REQUEST FOR PROPOSALS No. 22-010

***PROFESSIONAL ENGINEERING SERVICES
FOR
AC WATERMAIN REPLACEMENT DESIGN FOR MADRONA AND RED GAP
NEIGHBOURHOODS IN THE NANOOSE BAY PENINSULA WATER SERVICE AREA***

**Addendum 1
Issued: February 17, 2022**

The excluded pipe locations are highlighted in the following figure.

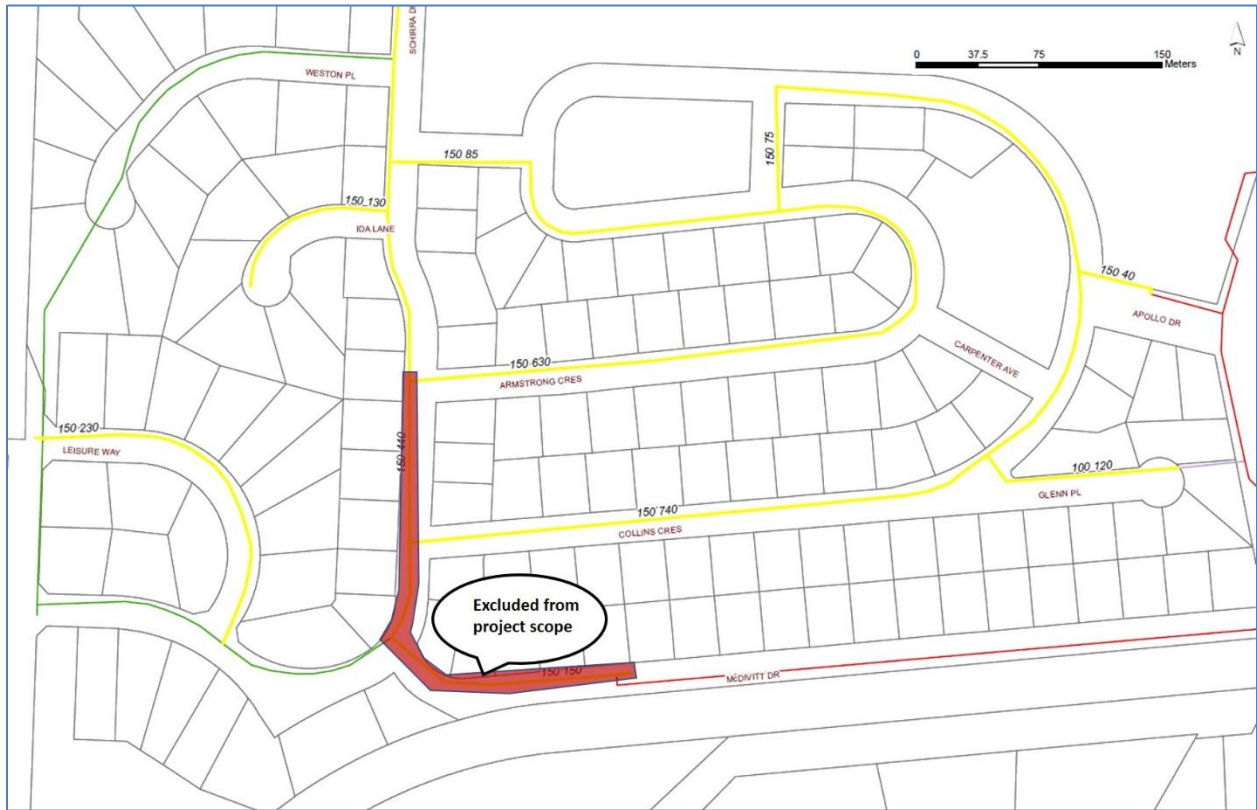
The watermain pipes in the following locations will be excluded from the scope of this design project since they were replaced with PVC pipes in recent years.

Location 1: Schirra Dr between Armstrong Cres and McDivitt Dr

Location 2: McDivitt Dr

Total (approx.) length of pipes on locations 1&2: 330 m.
